HISTORIC AND DESIGN REVIEW COMMISSION

HDRC CASE NO: 2018-481
ADDRESS: 1811 N PALMETTO
LEGAL DESCRIPTION: NCB 993 BLK 3 LOT 20 & E 27.9 OF S 62.5 OF N 125 OF 7
ZONING: R-6, HS
CITY COUNCIL DIST.: 2
DISTRICT: Government Hill Historic District
APPLICANT: Diana Orosco
OWNER: Diana Orosco
TYPE OF WORK: Replacement of the existing, standing seam metal roof with an asphalt shingle roof
APPLICATION RECEIVED: September 14, 2018
60-DAY REVIEW: November 13, 2018
REQUEST:

The applicant is requesting a Certificate of Appropriateness for approval to replace the existing, standing seam metal roof with an asphalt shingle roof.

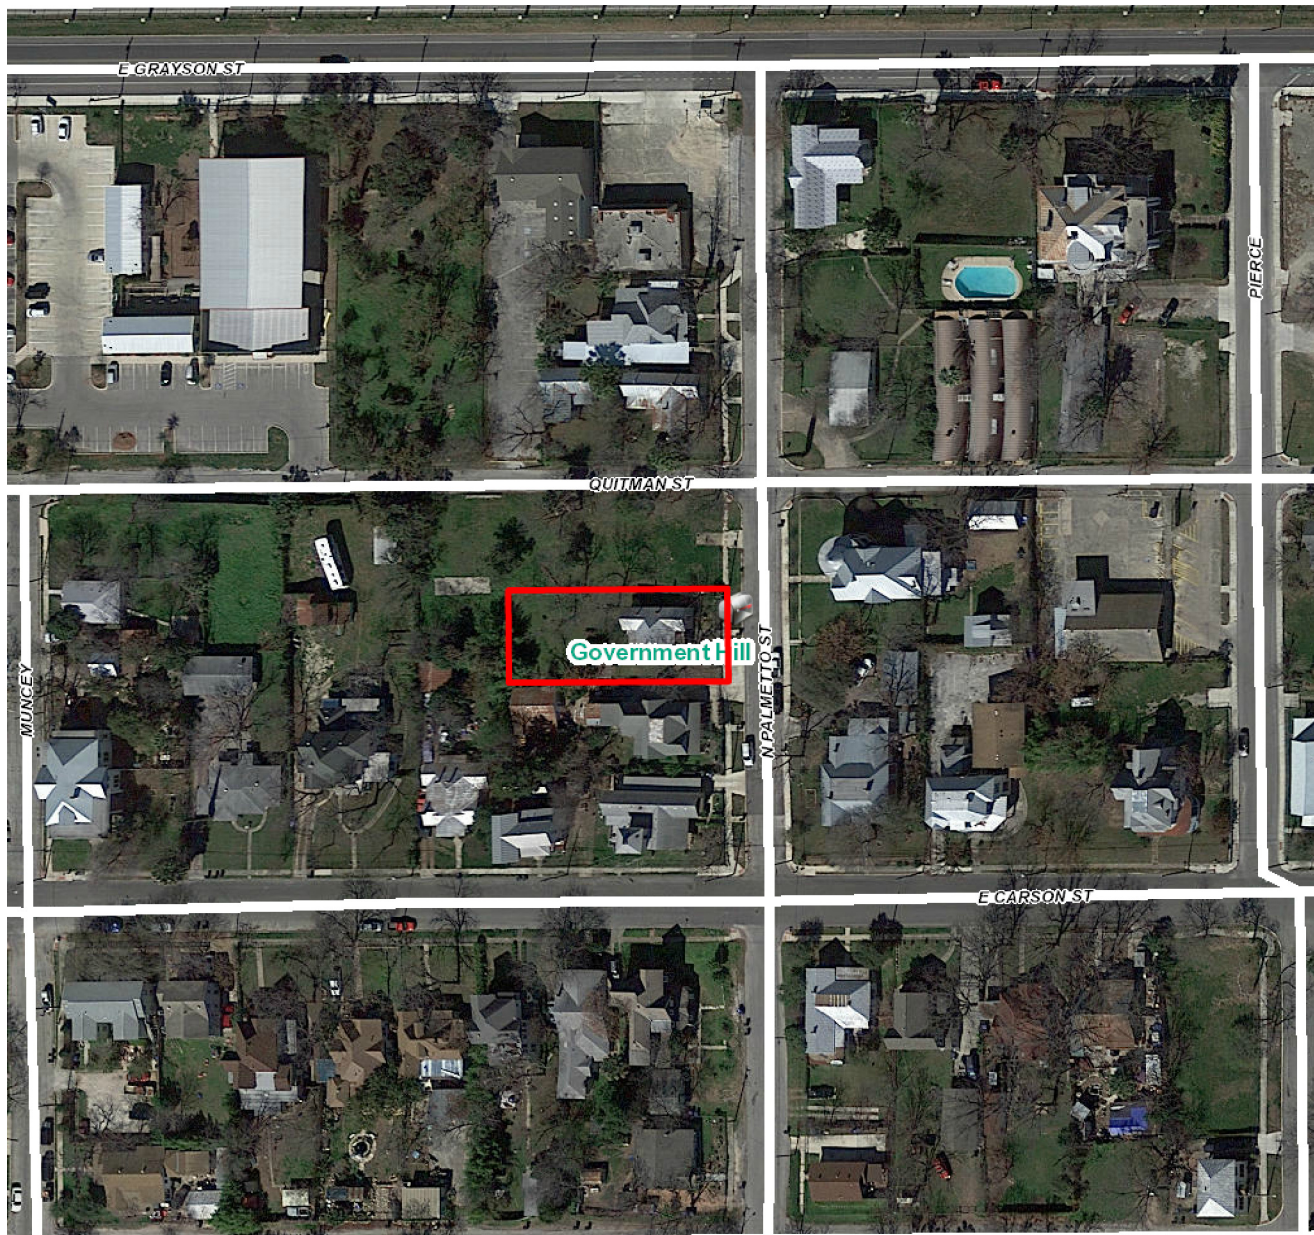
- a. The historic structure located at 1811 N Palmetto was constructed circa 1910 and is first found on the 1912 Sanborn Map. The structure was constructed in the Folk Victorian style and features a standing seam metal roof, two brick chimneys and turned columns.
- b. ROOF REPLACEMENT – The Guidelines for Exterior Maintenance and Alterations 3.B.vi. notes that metal roofs should be used on those where a metal roof is appropriate for the style of construction or on structures that historically featured a metal roof. The 1912 Sanborn Map notes a non-combustible roof, in this instance, metal. Staff finds that the proposed asphalt shingle roof is not consistent with the Guidelines and finds that a metal roof should be installed to be consistent with the Guidelines.

Staff does not recommend approval based on finding b. Staff recommends that a standing seam metal roof be installed to feature panels that are 18 to 21 inches in width, seams that are 1 to 2 inches in height, a crimped ridge seam and a standard galvalume finish.

A roof inspection is to be scheduled with OHP staff 24 hours prior to the start of roof replacement to ensure that a crimped ridge seam is to be installed.
